## ADDENDUM NO. 4 – May 6, 2021

### REQUEST for QUALIFICATIONS/PROPOSAL for ARCHITECTURAL SERVICES STAPLES HIGH SCHOOL ROOF REPLACEMENT PROJECT BID #21-010-RFP

**STAPLES SCHOOL  
70 NORTH AVENUE  
WESTPORT, CT**

Project: Staples School, Westport

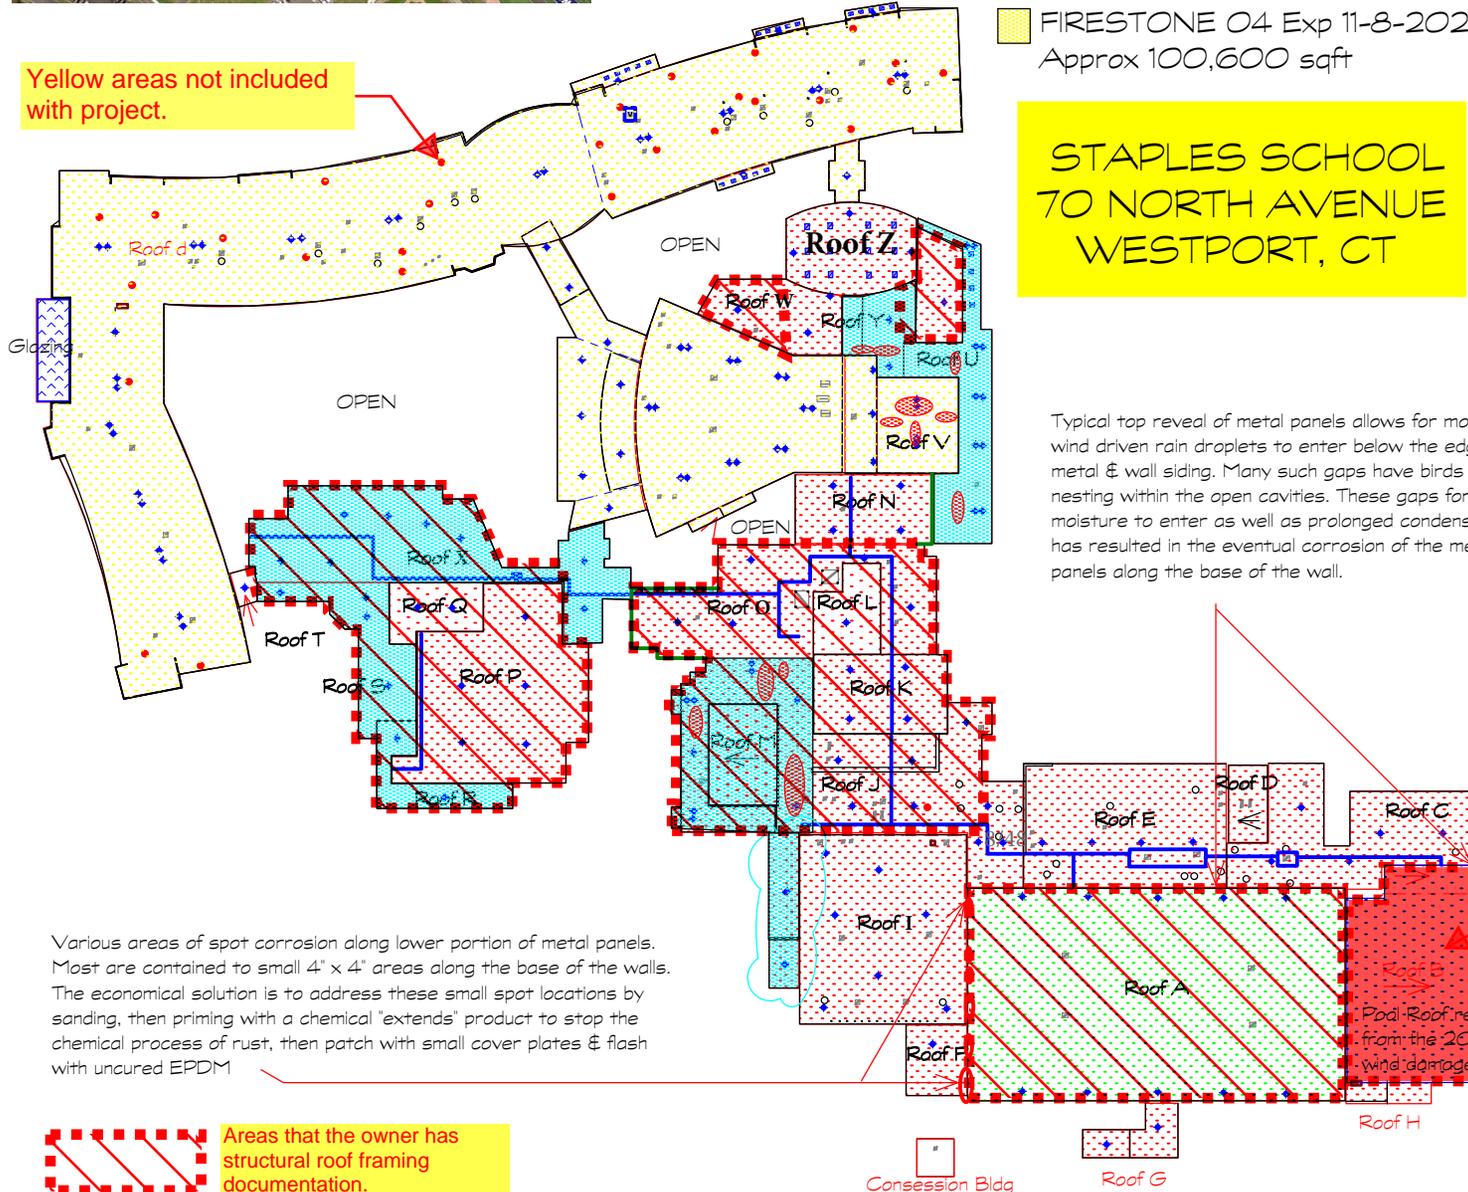
**Answer:** Multiple sets of documentation have been located with varying degrees of information that will be made available to the selected architect for the project. Attached is a marked-up version of the roof legend contained in Exhibit D of the RFP that delineates areas where structural information was found. Areas where information was not found may still be available in the district archives but shall be assumed as not available. All proposers shall include the appropriate field time to verify existing structural conditions in these areas.

Areas that the owner has structural roof framing documentation.
